CONSTRUCTION PLANS FOR

NOR ESTE MANOR SUBDIVISION

DRAINAGE, GRADING, PAVING AND UTILITY
IMPROVEMENTS

NOTE:
SHEETS AFFECTED BY CHANGE ORDER #1
AS INDICATED

TITLE: **NOR ESTE MANOR**
ANAHEIM AVE. N.E. STA. 0+00.00 TO STA. 11+00.00
UTILITY PLAN AND PROFILE

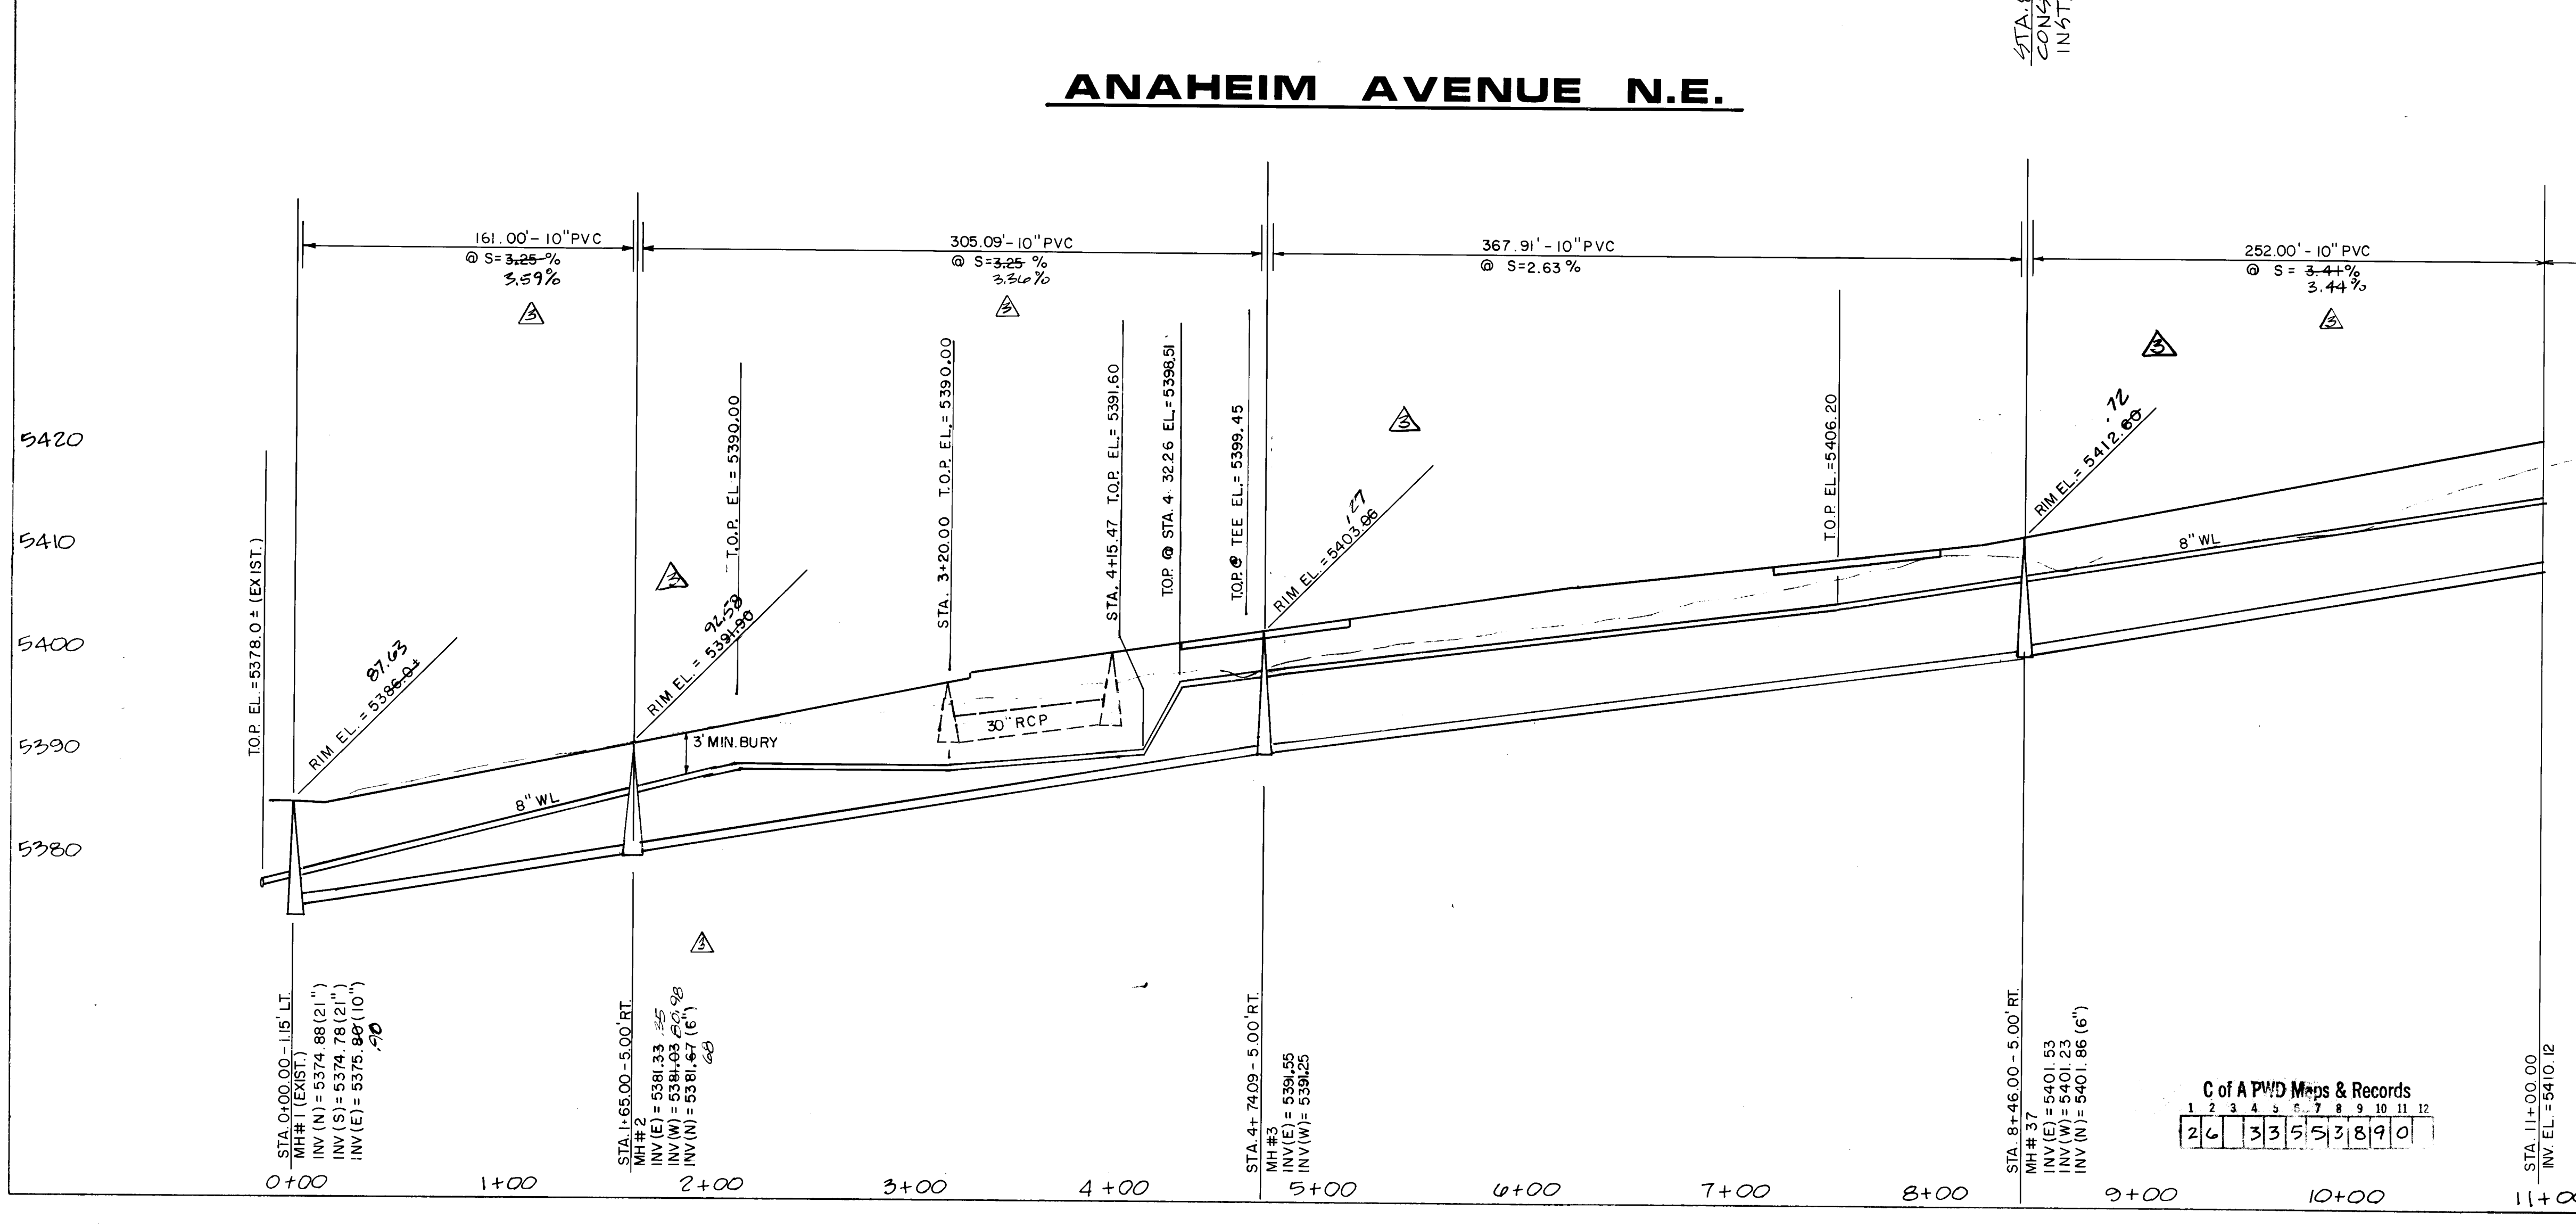
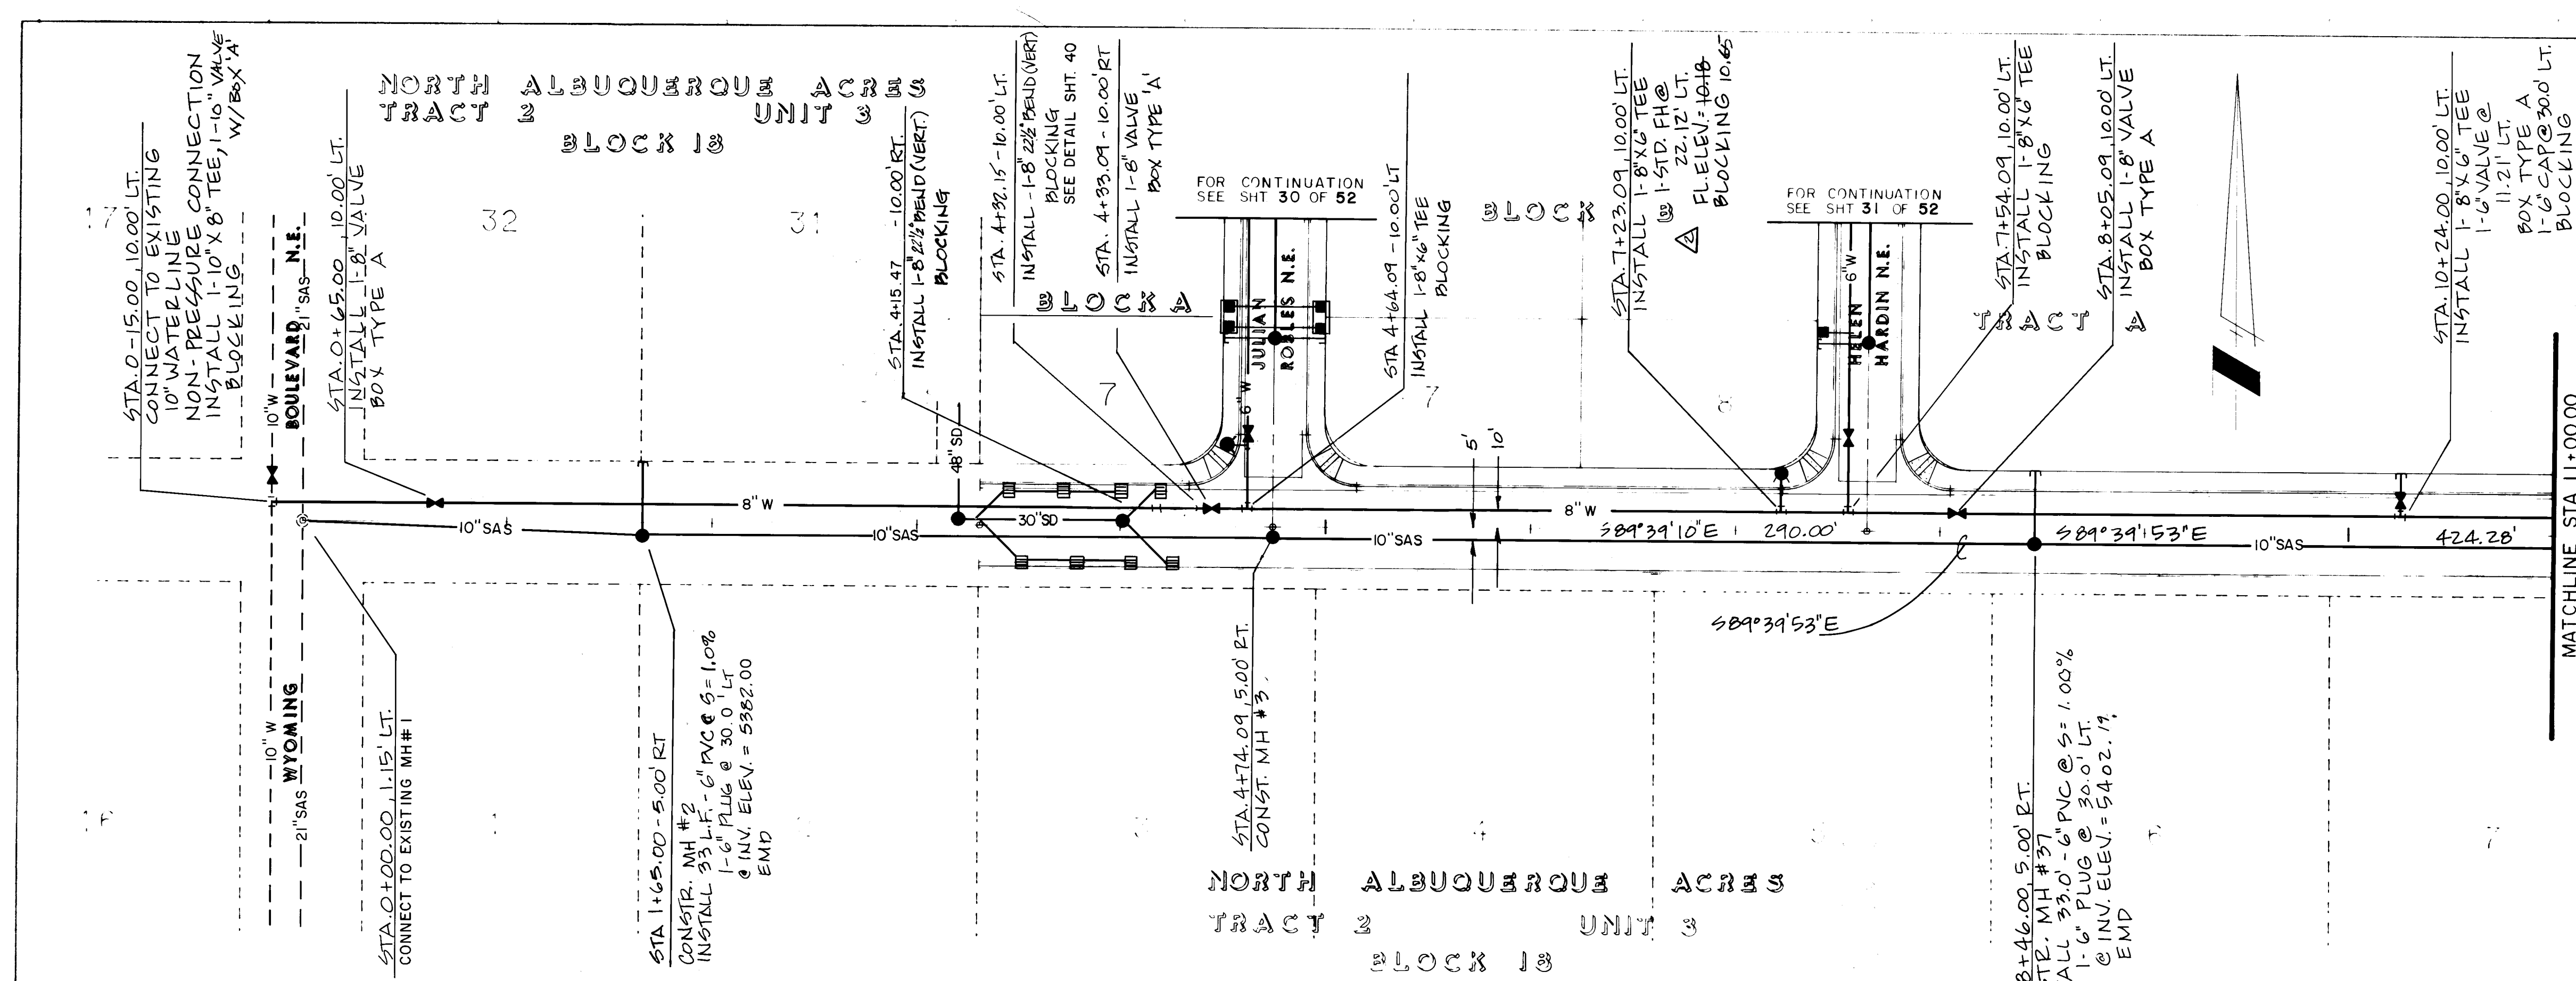
CHANGE ORDER NO. 1

REVISE/REGRADE SEWER/WATER

NOR ESTE MANOR
ANAHEIM AVE NE STA. 11+00.00 TO STA. 22+00.00
UTILITY PLAN AND PROFILE

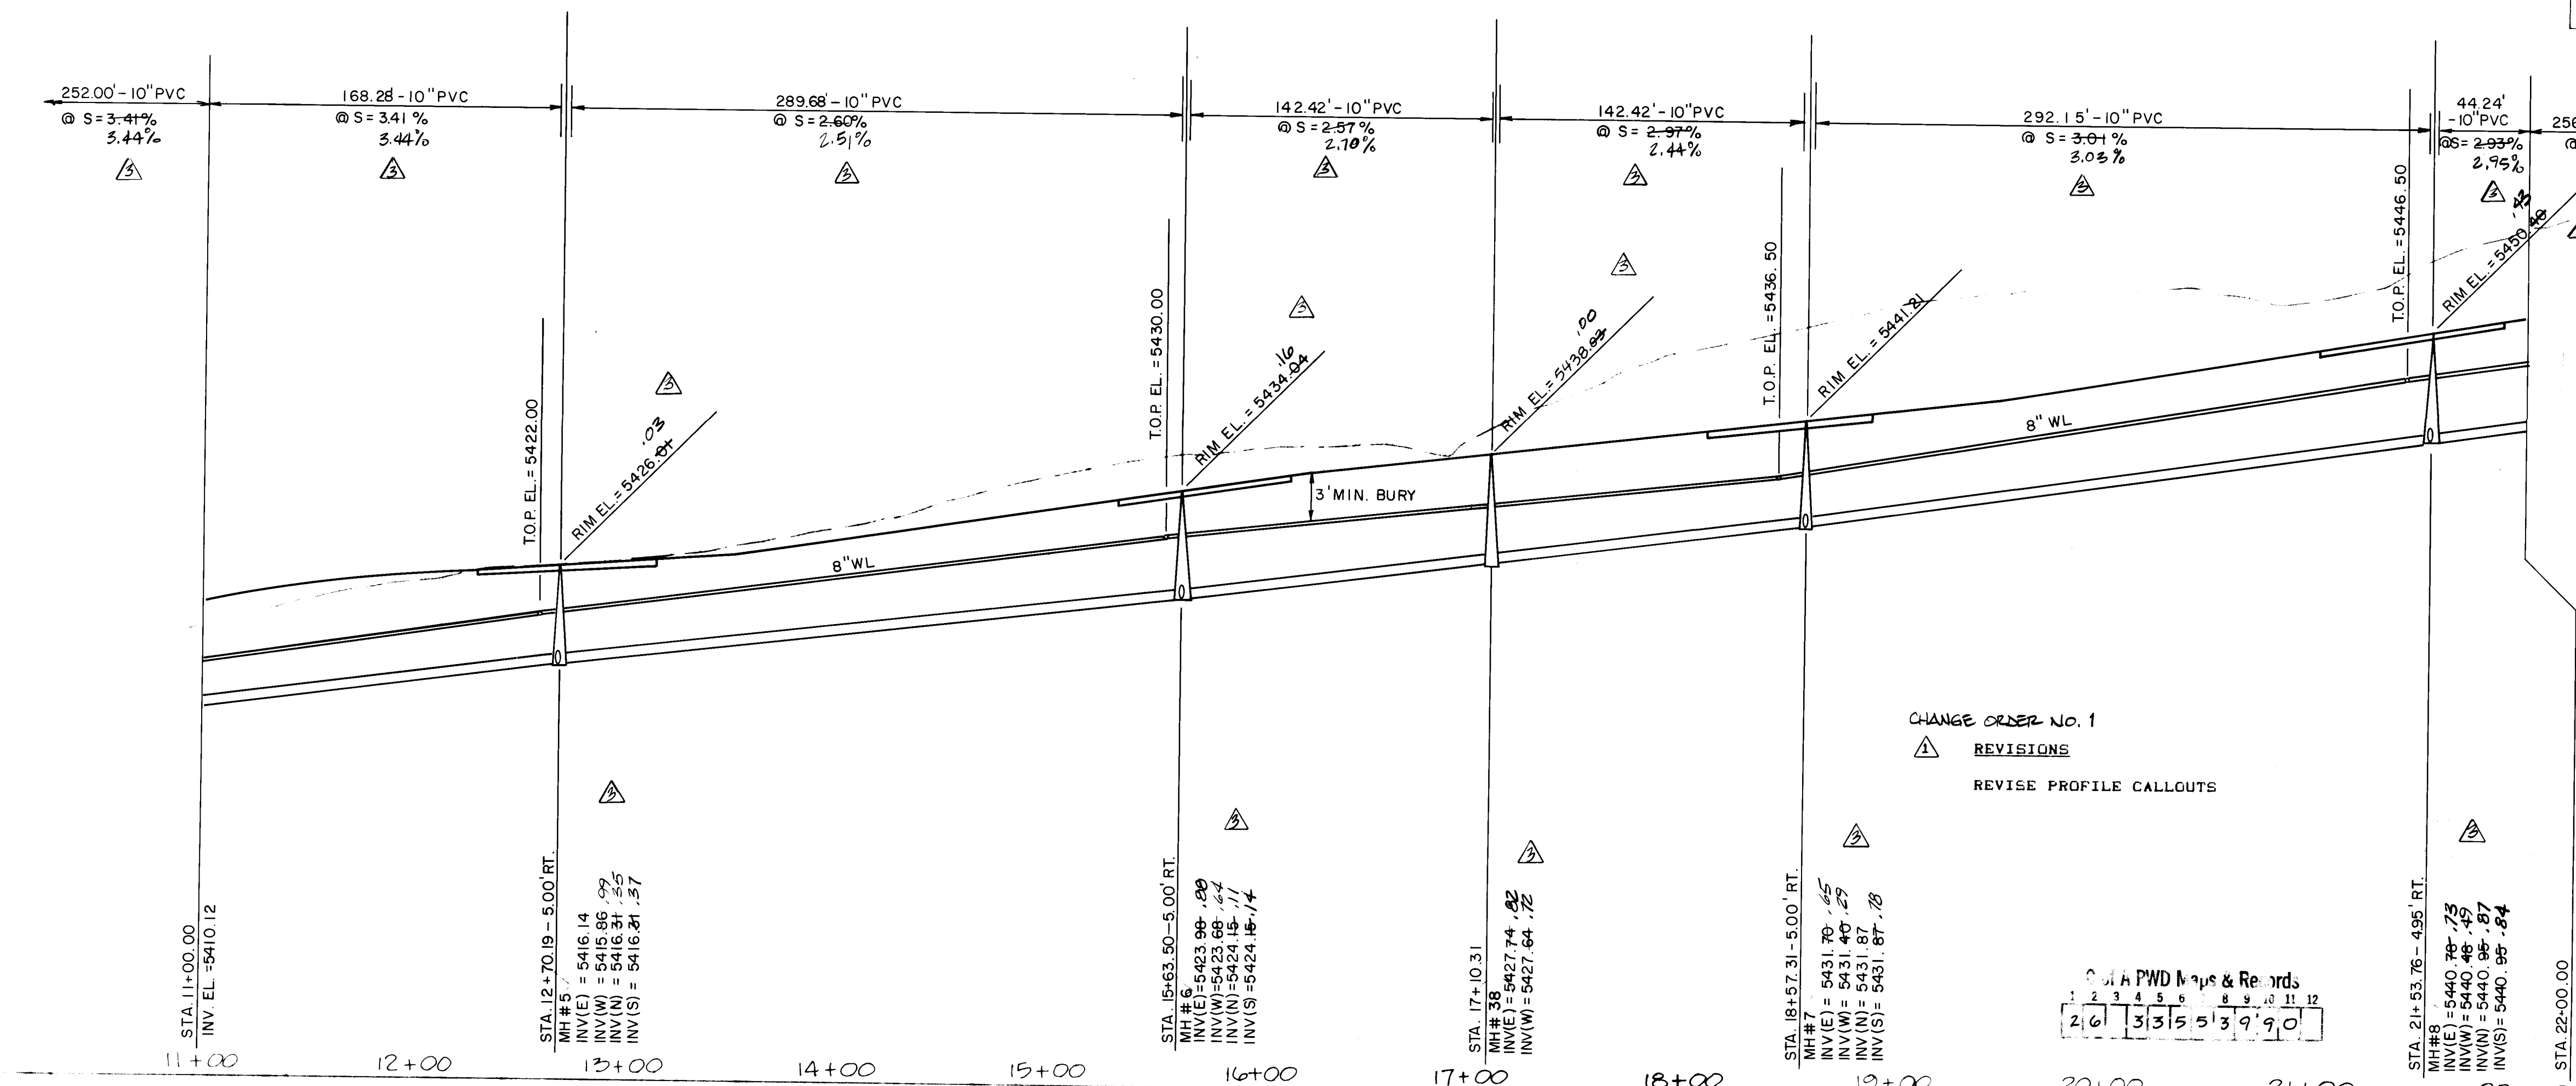
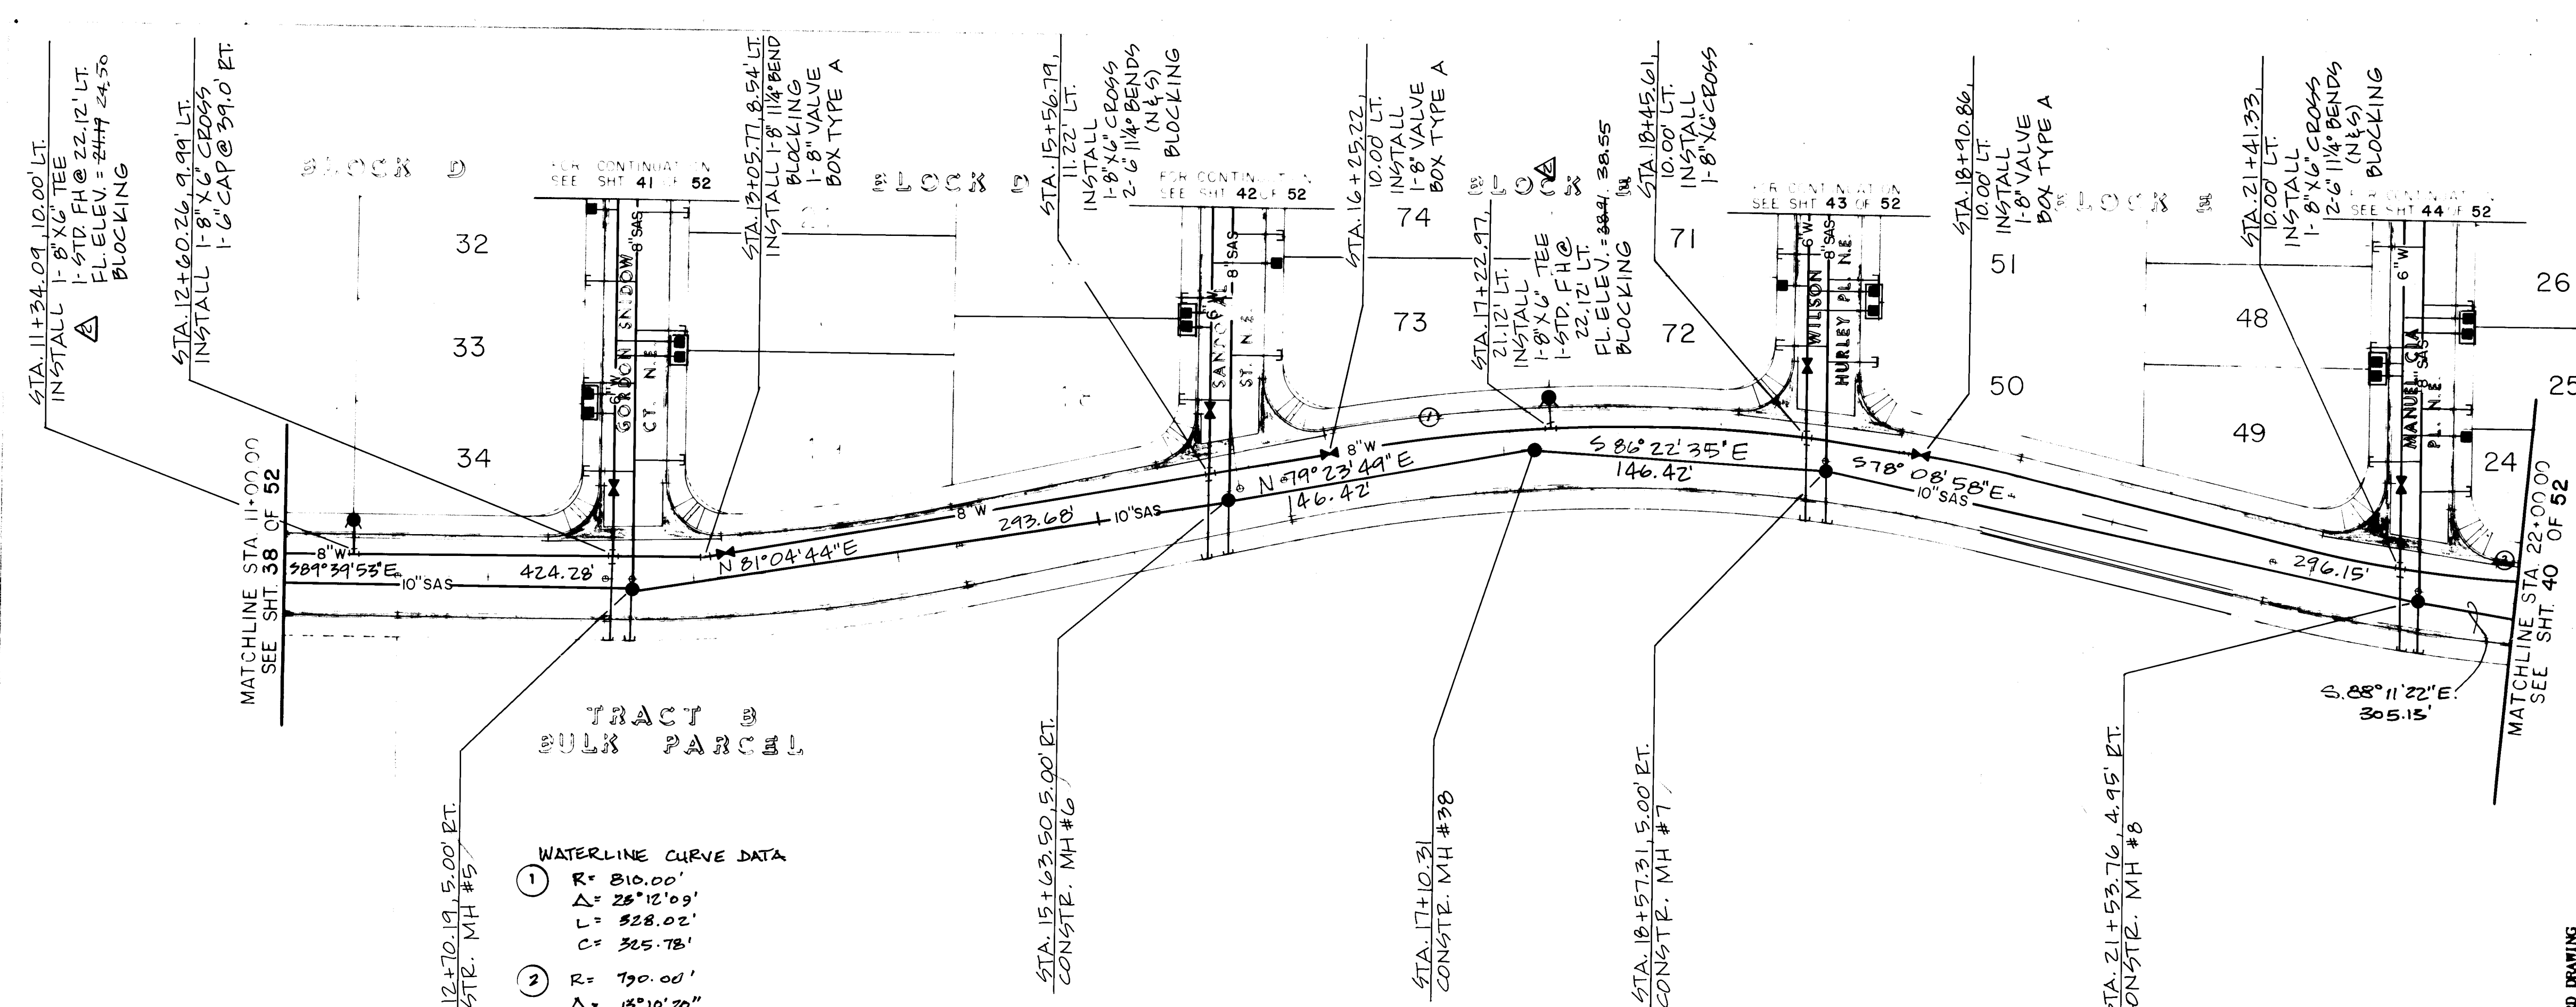
CHANGE ORDER NO. 1

REVISE PROFILE CALLOUTS
